# Anthropomorphic Test Devices; Six-Year-Old Crash Test Dummy

**ACTION:** Final rule; correcting amendment.

2. By revising Figure N5 to Subpart N to read as follows:

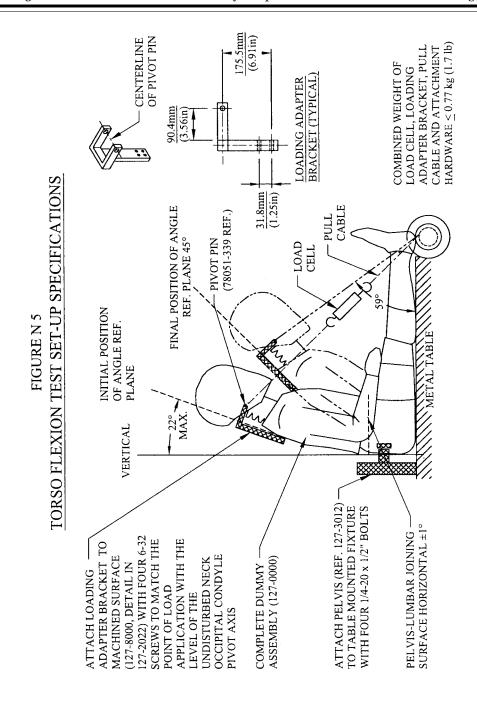
- Figure N5: Change bracket dimensions from "89.9 mm (3.54 in) x 161.3 mm (6.35 in) x 31.8 mm (1.251 in)" to "90.4 mm (3.56 in) x 175.5 mm (6.91 in) x 31.8 mm (1.25 in)".

No changes were made to Figure N1. Figure N1, rather than Figure N5 was

inadvertently sent to the **Federal Register** as part of the final rule. Accordingly, the changes that were made to figure N5 do not appear in the revised regulatory text. Today's amendment corrects that error.
